**City of Saginaw Public Library
and Senior Center
1005702.00
320 W McLeroy Blvd,
Saginaw, TX 76179**

Saginaw Senior Center & Library Update

2021 BOND PROGRAM

**SITE PLAN
FOR
SAGINAW LIBRARY & SENIOR CENTER
SAGINAW, TEXAS**

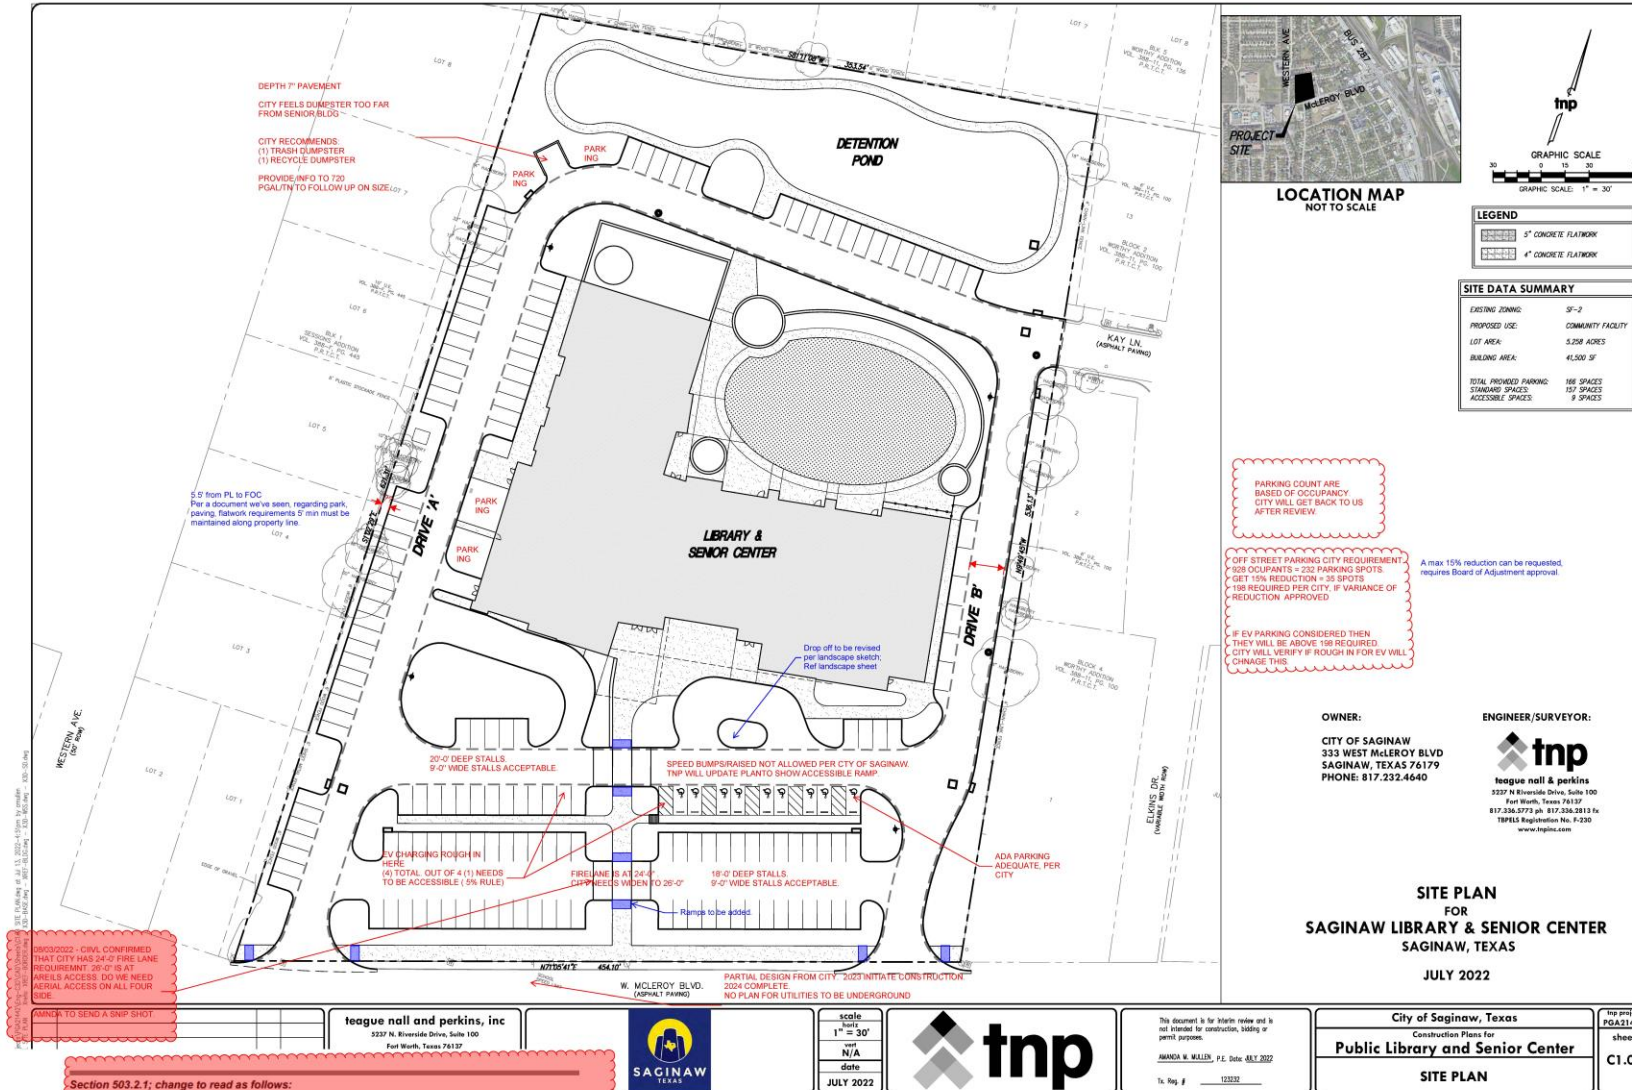
PARKING COUNT ARE
BASED OF OCCUPANCY.
CITY WILL GET BACK TO U
AFTER REVIEW.

OFF STREET PARKING CITY REQUIREMENT.
928 OCUPANTS = 232 PARKING SPOTS.
GET 15% REDUCTION = 35 SPOTS
198 REQUIRED PER CITY, IF VARIANCE OF
REDUCTION APPROVED

A max 15% reduction can be requested
requires Board of Adjustment approval.

IF EV PARKING CONSIDERED THEN
THEY WILL BE ABOVE 150 REQUIRED.
CITY WILL VERIFY IF ROUGH IN FOR EV WILL
CHNGE THIS.
